Addendum No.6
Maple Street Shelter

MAPLE STREET SHELTER
1580 Maple Street
Redwood City, CA
Project No. PC019

Issued on September 27, 2016

SHEET: JDP-1

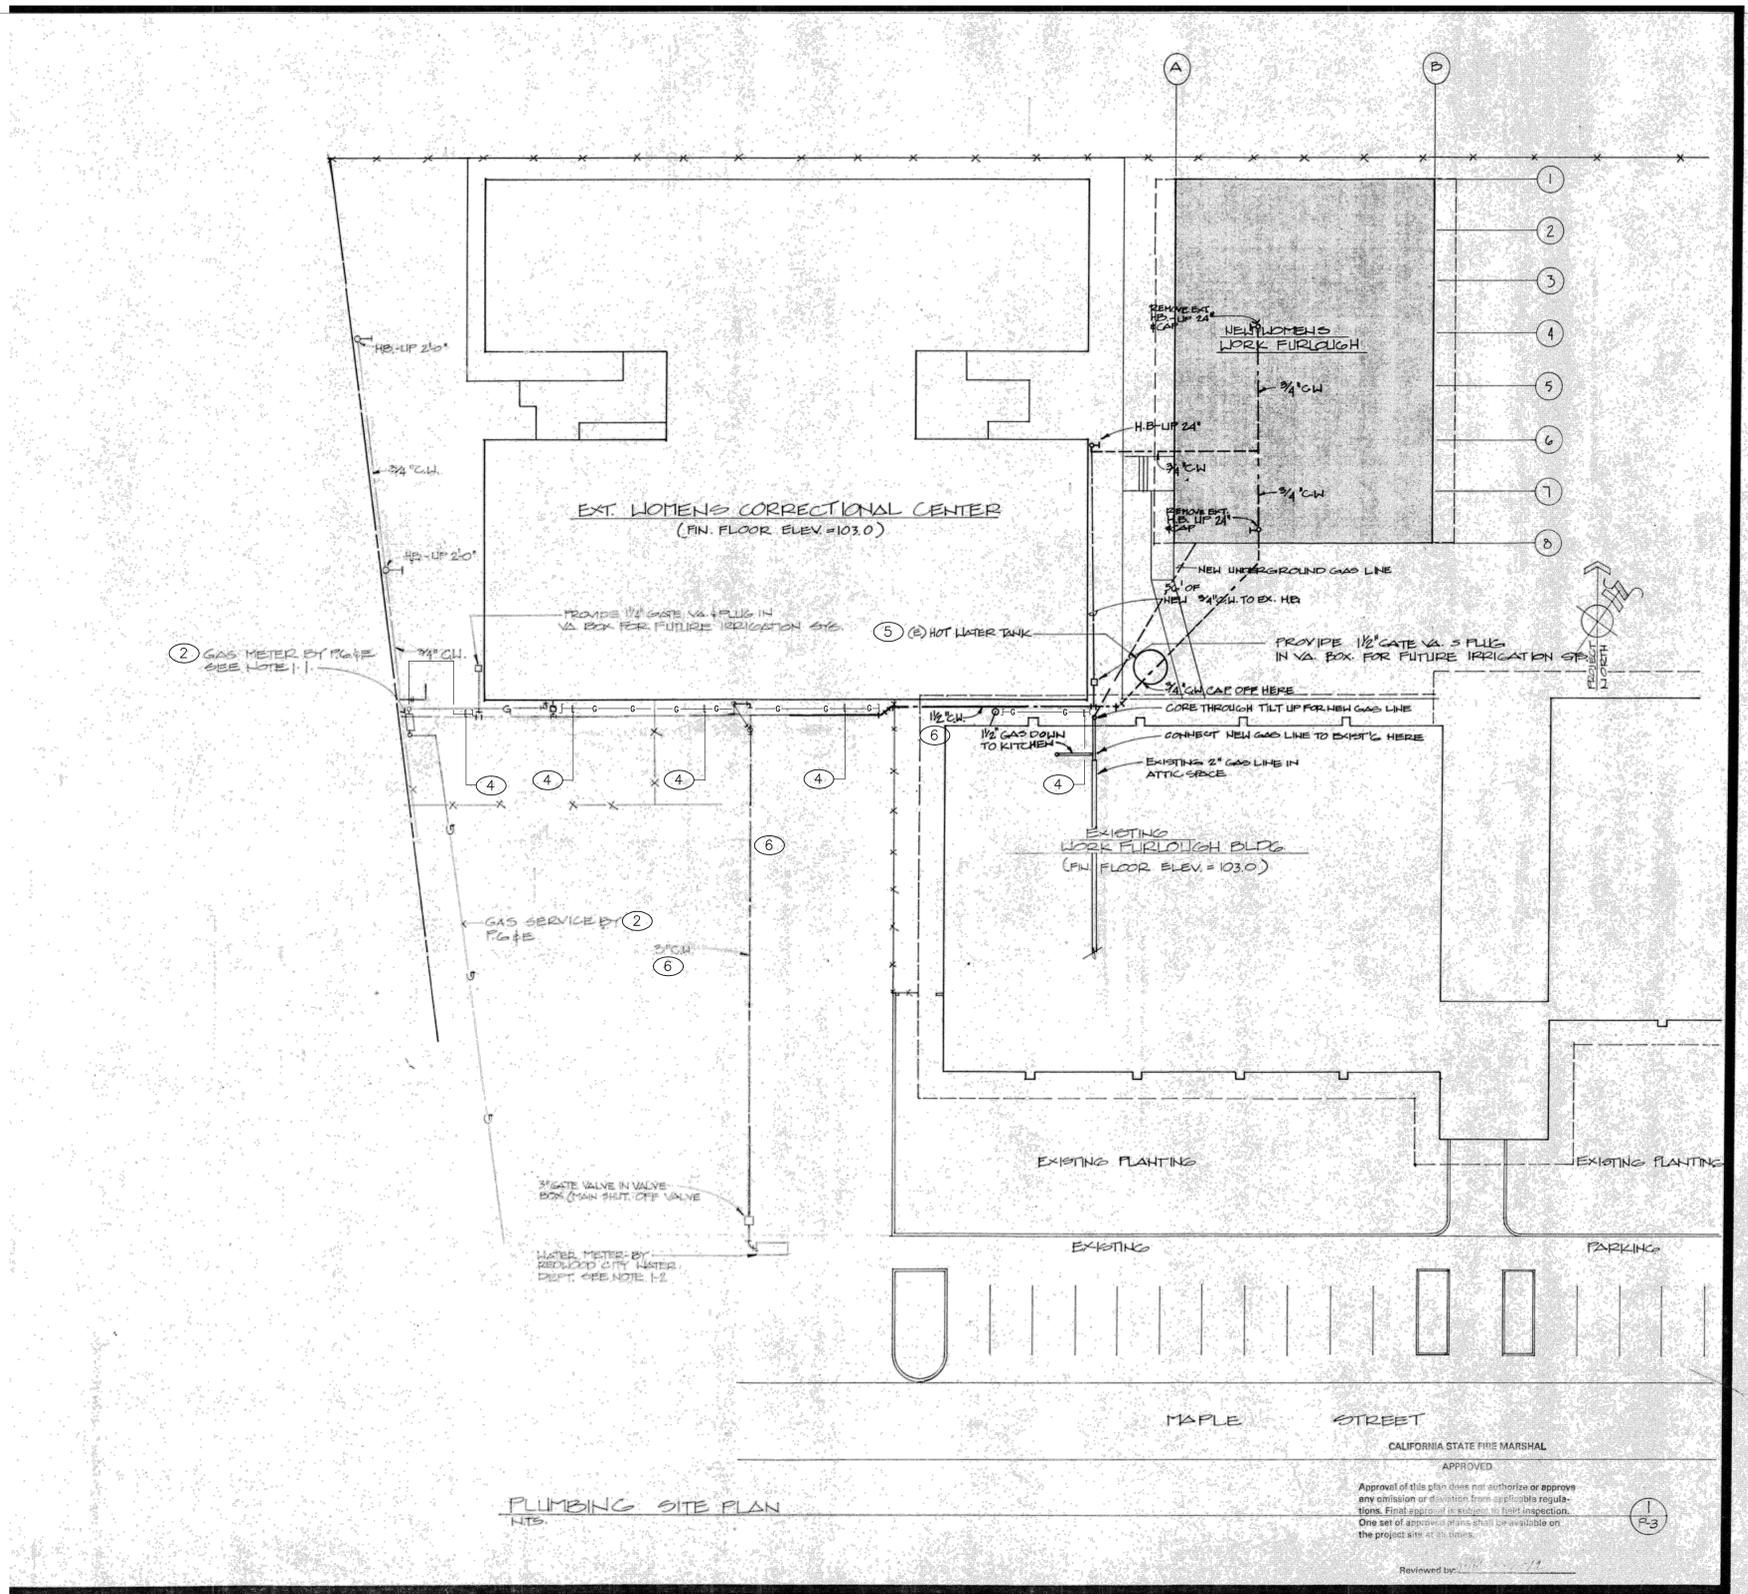
- 1 THE PLAN SHOWN ON THIS SHEET IS TAKEN FROM AVAILABLE RECORD DRAWINGS DATED 1977 FOR THE EXISTING WOMEN'S JAIL BUILDING WHICH SHALL BE DEMOLISHED AS PART OF PHASE ONE OF THIS PROJECT. THE CONTRACTOR SHALL PERFORM THE NECESSARY SITE VISITS TO FIELD VERIFY EXISTING CONDITIONS AND SHALL NOT RELY ON THIS DRAWING FOR 100% ACCURATE AS BUILT CONDITIONS.

- 3 THE CONTRACTOR SHALL DEMOLISH AND REMOVE ALL EXISTING PLUMBING UNDERGROUND SITE UTILITIES TO THE BUILDING INCLUDING SEWER LINES, WATER LINES, WATER METER, STORM DRAIN LINES, AND GAS LINES. VERIFY CONDITIONS IN FIELD. REFER TO SHEET JDP-2.

- 5 THE CONTRACTOR SHALL DEMOLISH AND REMOVE AND DISPOSE OF EXISTING ROOFTOP SOLAR WATER HEATING PANELS, NOT SHOWN ON THIS PLAN. THE WORK WILL ALSO INCLUDE DEMOLITION OF EXISTING SOLAR HOT WATER PIPING DISTRIBUTION SYSTEMS TO THE SHELTER BUILDING (ABOVE ROOF), THE EXISTING PIPING DISTRIBUTION TO THE MODULAR WORK FURLOUGH BUILDING (ABOVE ROOF AND UNDERGROUND) AND THE EXISTING SOLAR HW STORAGE TANK ON CONCRETE PAD ON SITE, AND ASSOCIATED SUPPORTS, PUMPS, CONTROLS, AND PIPE INSULATION. REFER TO SHEET JDP-2.

SHEET TITLE
Modular Work
Furlough Bldg
Plumbing Site Plan -
Demolition

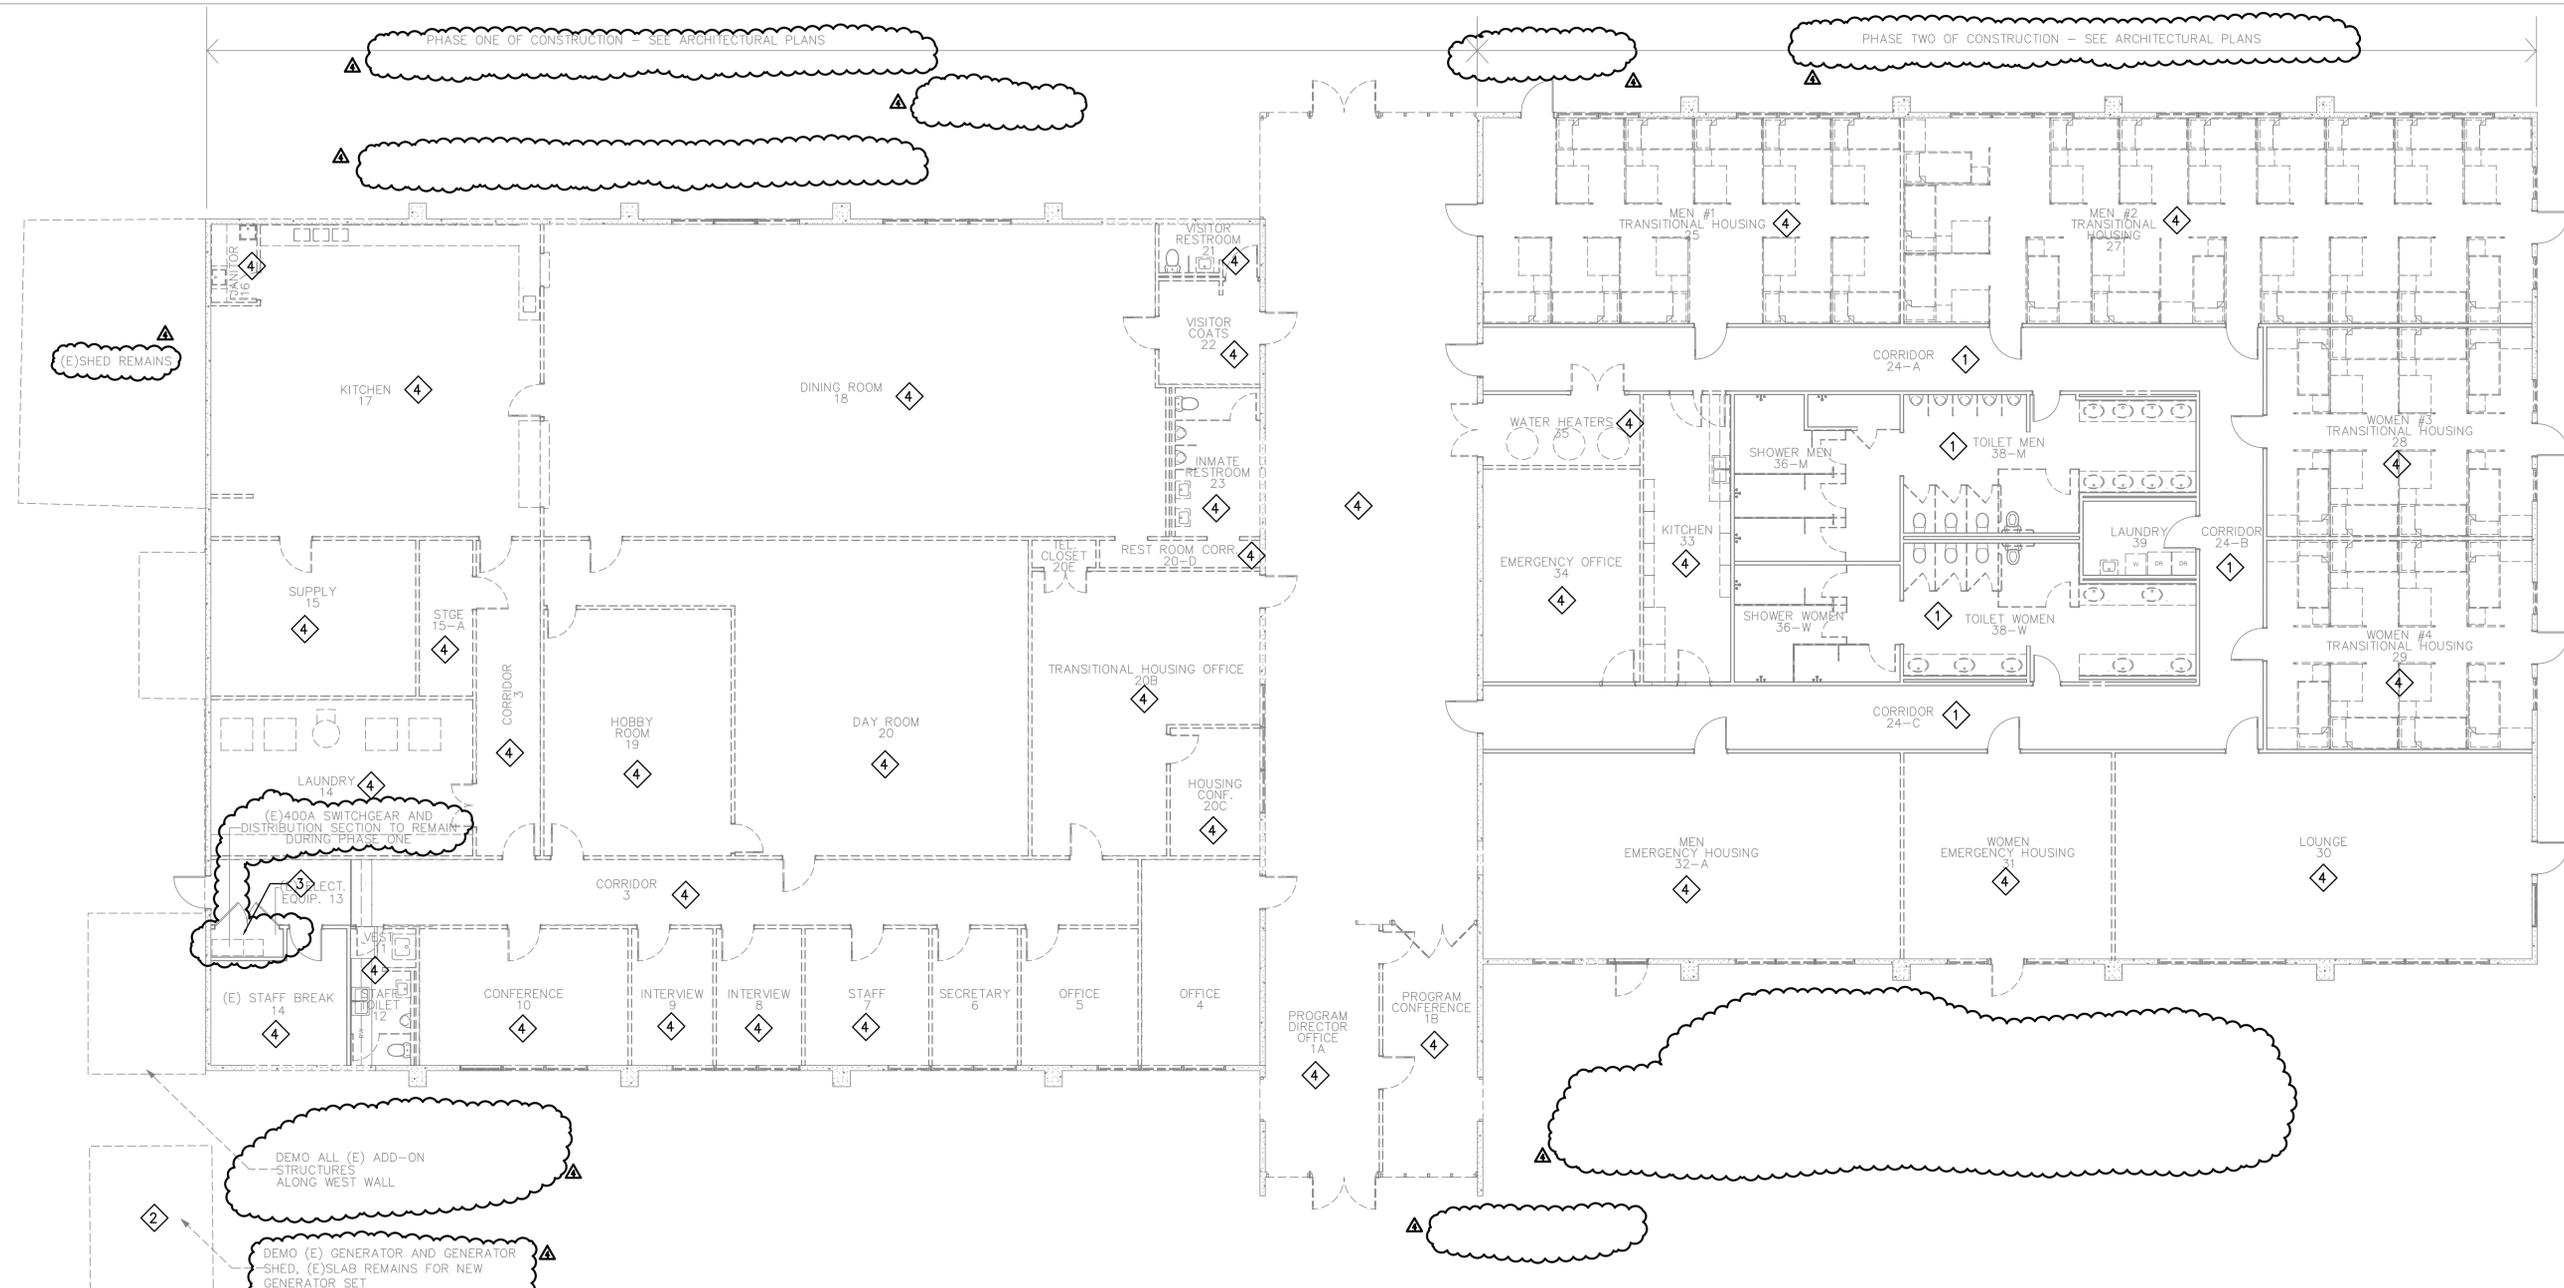
- THE CONTRACTOR SHALL DEMOLISH AND REMOVE 2-INCH GAS LINE FROM WOMENS JAIL BUILDING SERVING THE MODULAR WORK FURLOUGH BUILDING FROM THE RISER AT WOMENS JAIL BUILDING TO THE GAS METER MANIFOLD AREA. THE EXISTING GAS METER WHICH SERVES THE WOMENS JAIL BLDG AND THE WOMENS JAIL BUILDING, SHALL REMAIN. THE EXISTING UNDERGROUND 2-INCH BRANCH GAS LINE FROM GAS METER TO WOMENS JAIL BUILDING SHALL BE DEMOLISHED, REMOVED, AND CAPPED OFF AT MANIFOLD. SEE SHEET SE-2 FOR EXISTING GAS LINES.

- THE EXISTING 2-INCH EXISTING UNDERGROUND 2-INCH BRANCH GAS LINE FROM GAS METER TO WOMENS JAIL BUILDING ROOF, WHICH SERVES WORK FURLOUGH BUILDING, SHALL BE PARTIALLY DEMOLISHED AND REMOVED. THIS SHALL OCCUR AS PART OF PHASE ONE FOR PROJECT. SEE SHEET SE-2 FOR EXISTING GAS LINES.

- DEMOLISH AND REMOVE EXISTING SOLAR HW STORAGE TANK ON SITE REFER TO SHEET JDP-1.
- THE CONTRACTOR SHALL VERIFY SOURCE OF DOMESTIC WATER SERVICE TO THE EXISTING MODULAR WORK FURLOUGH BLDG. THE SERVICE SHALL REMAIN INTACT. IF THE EXISTING 3-INCH MAIN SERVING THE WOMENS JAIL BLDG IS ALSO SERVING THE WORK FURLOUGH MODULAR BLDG, THEN THE UNDERGROUND LINE AND EXISTING WATER METER SHALL REMAIN IN SERVICE.

1 Demo Plan-Electrical

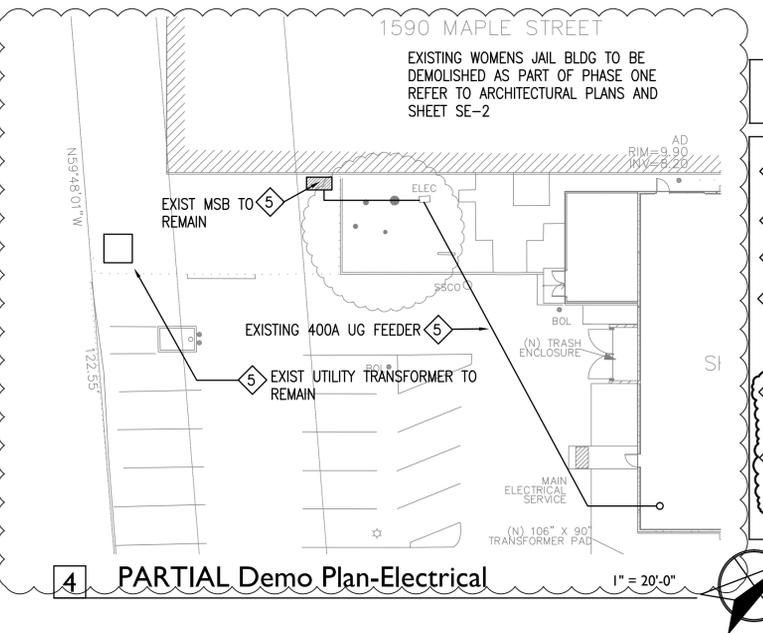
- 6 EXISTING 350A FEEDER FROM (E)MSB SERVING EXISTING MODULAR WORK FURLOUGH BLDG TO BE REWIRED AND ROUTED AS PART OF PHASE 1B AFTER EXISTING WOMEN'S JAIL BLDG IS DEMOLISHED. EXISTING FEEDER AND 4-INCH CONDUIT RUNS ABOVE ROOF OF WOMEN'S JAIL BLDG AND NEEDS TO BE REROUTED UNDERGROUND. SEE SHEET SE-2.

◦ SHEET: E4.6

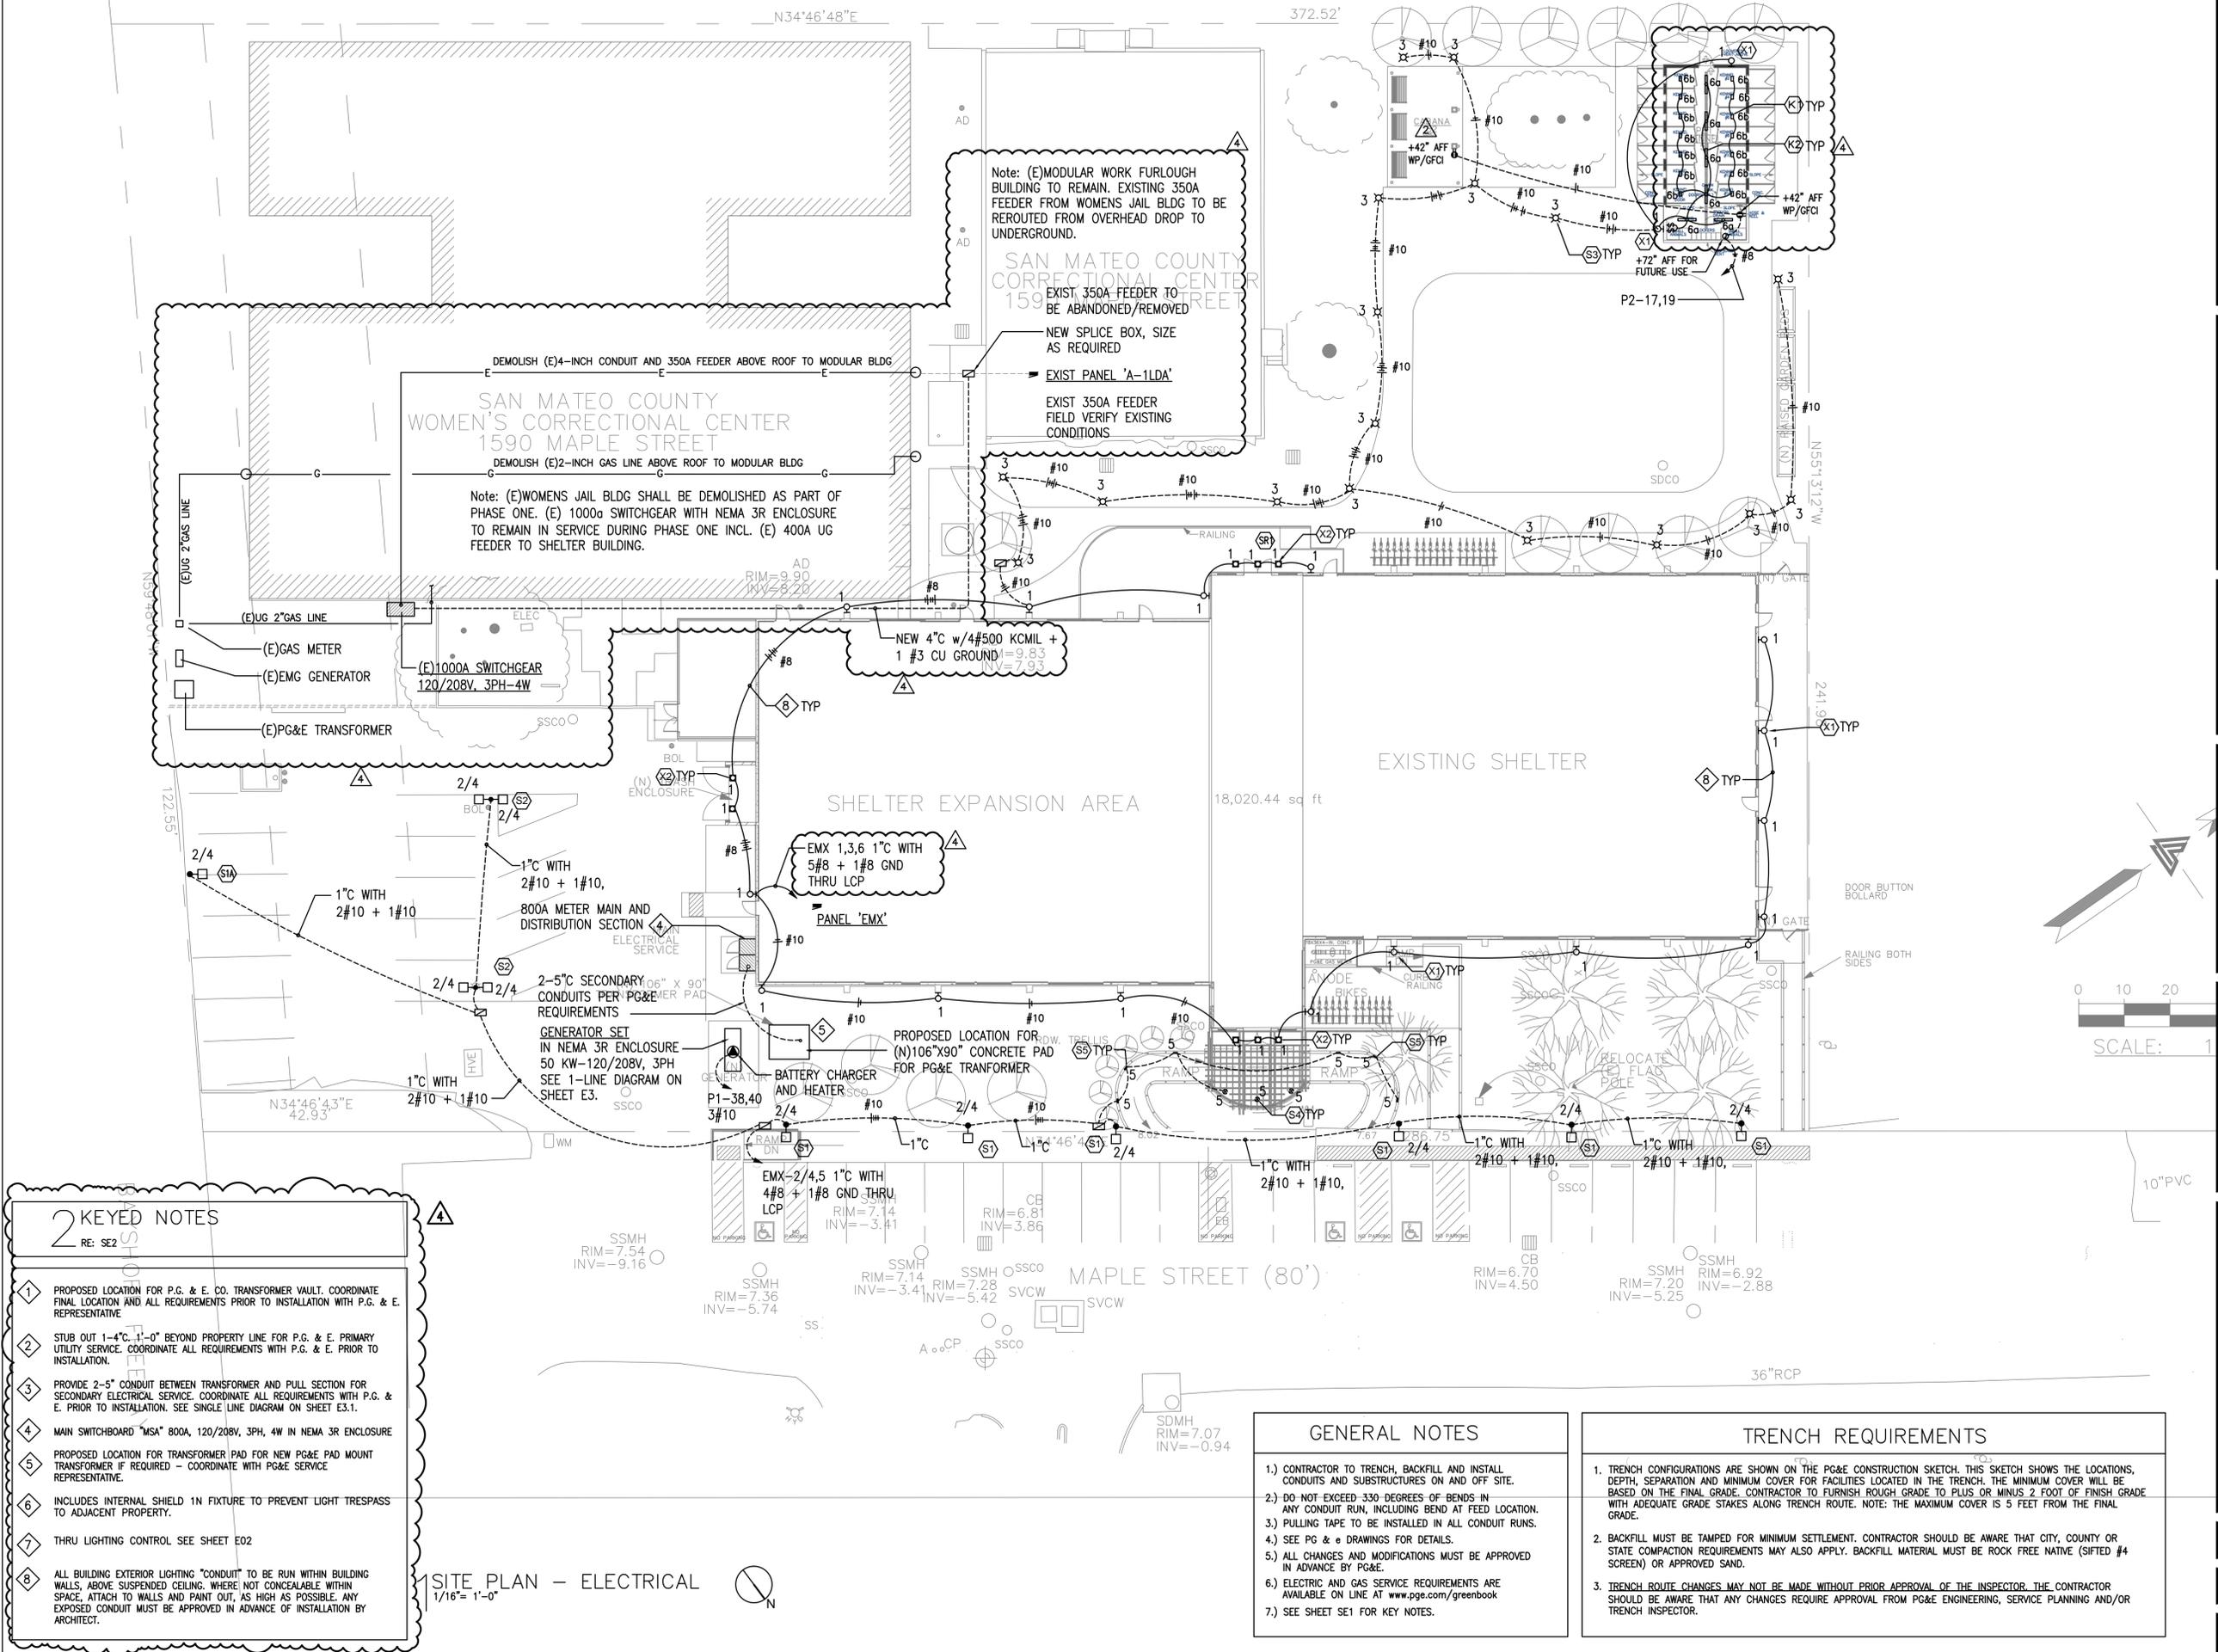
Note: (E)MODULAR WORK FURLOUGH BUILDING TO REMAIN. EXISTING 350A FEEDER FROM WOMENS JAIL BLDG TO BE REROUTED FROM OVERHEAD DROP TO UNDERGROUND.
EXIST 350A FEEDER TO BE ABANDONED/REMOVED
NEW SPICE BOX, SIZE AS REQUIRED
EXIST PANEL 'A-1LDA'
EXIST 350A FEEDER FIELD VERIFY EXISTING CONDITIONS
